Amendments to the Drawings

REMARKS

Serial No. 10/597,906
Filed: May 8, 2007
Page 15 of 15

Figure 2

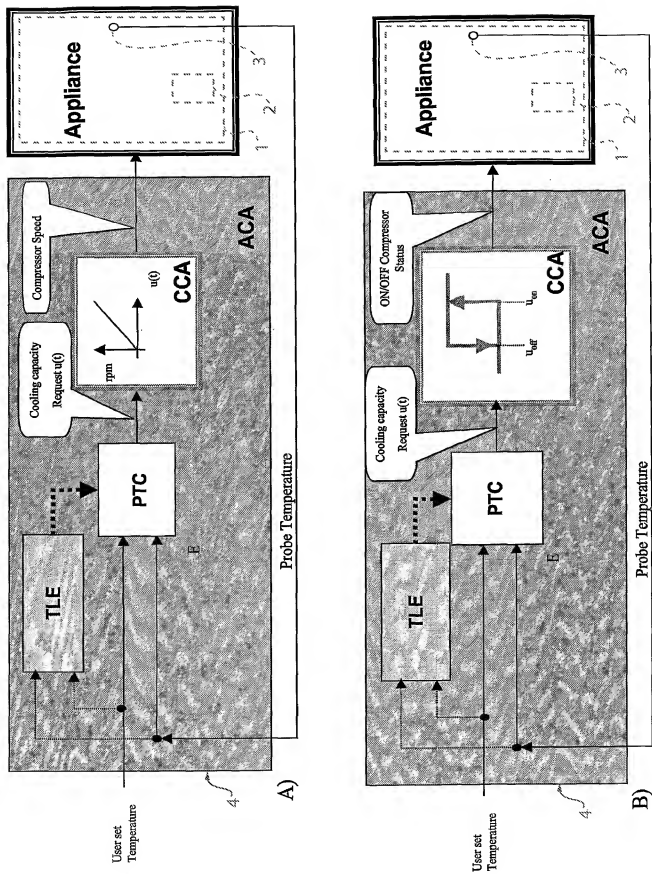
The drawings are objected to under 37 CFR 1.83(a) for failure to show the “cooling chamber”, “compressor”, “temperature sensor”, and “controller” of the claims. Applicants have amended Figures 2A and 2B to show numeric representation for the cooling chamber, compressor, temperature sensor, and controller. Applicants believe this amendment to be fully supported by the claims and the application as filed, and respectfully request withdrawal of the objection.

Kindly replace the original drawing sheet containing Figures 2A and 2B with the attached Replacement Sheet containing amended Figures 2A and 2B. An Annotated Sheet with a marked-up version of Figures 2A and 2B is provided to assist the Examiner in readily identifying the amendments made to Figures 2A and 2B. In particular, numeric representation of the cooling chamber, compressor, temperature sensor, and controller has been added to the figures to support the features of the invention specified in the claims.

Figures 2A and 2B of the drawings have been amended to include numeric representation of the cooling chamber, compressor, temperature sensor, and controller. Support for this amendment can be found throughout the substitute specification.
